Access Compliance Report

Public Rights-of-Way

(Curb Ramps)

Intersection ID: N/A	Main Street: RIDGE_OAK_DR	Cross Street: SHADOW_RIDGE_LN	Location: SW
ADA ID: 14310F80EA38	Ramp Type: BlendTrans2	Initial Pass/Fail: Fail	Overall Compliance: No
		Severity Score: 12.5

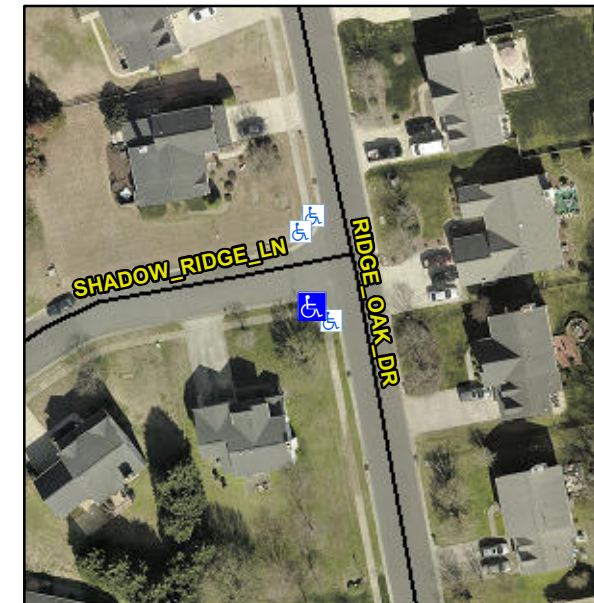
Not Found, R304.5.3

Compliance	Description	Data	Compliance	Description	Data
N/A	Ramp Length (in)	48.0	Yes	BlendTrans Slope (%)	2.6
Yes	Ramp Width (in)	48.0	No	BlendTrans XSlope (%)	5.4
N/A	Flare Type LT	N/A	N/A	Flare Type RT	N/A
N/A	Flare Slope LT (%)	N/A	N/A	Flare Slope RT (%)	N/A
N/A	Flare Traversable LT?	N/A	N/A	Flare Traversable RT?	N/A
N/A	Landing Length (in)	N/A	N/A	DWS Provided?	N/A
N/A	Landing Width (in)	N/A	N/A	DWS Contrast?	N/A
N/A	Landing Slope (%)	N/A	N/A	DWS Length (in)	N/A
N/A	Landing X Slope (%)	N/A	N/A	DWS Full Width?	N/A
N/A	Landing Curb? (Y/N)	N/A	N/A	DWS Offset (in)	N/A
N/A	Shared Landing?	N/A			
N/A	Gutter Ponding?	N/A	N/A	Gutter Slope (%)	N/A
N/A	Gutter Lip Ht (in)	N/A	N/A	Gutter X Slope (%)	N/A
N/A	Painted X Walk1?	No	N/A	Painted X Walk2?	N/A
	X Walk 1 Direction	To N		X Walk 2 Direction	N/A
	X Walk 1 Width (in)	N/A		X Walk 2 Width (in)	N/A
	X Walk 1 Slope (%)	5.0		X Walk 2 Slope (%)	N/A
	X Walk 1 X Slope (%)	3.0		X Walk 2 X Slope (%)	N/A

N/A	Ramp inside XWalk1?	N/A	N/A	Ramp inside XWalk2?	N/A
	Road Slope (%)	3.0		Clear Space?	N/A
	Road X Slope (%)	5.0	N/A	Clear Space to XWalk (in)	N/A
N/A	Any Obstructions?	N/A	N/A	Storm Grate/Utility Hazard?	N/A
	Obstruction Type			Storm Grate/Utility Type	
		N/A			N/A
			Yes	Surface Condition? (G/P)	Good
			No	Curb Slope (%)	11.8

Remove & Replace Curb Ramp With Two New Directional Ramps or Equivalent.
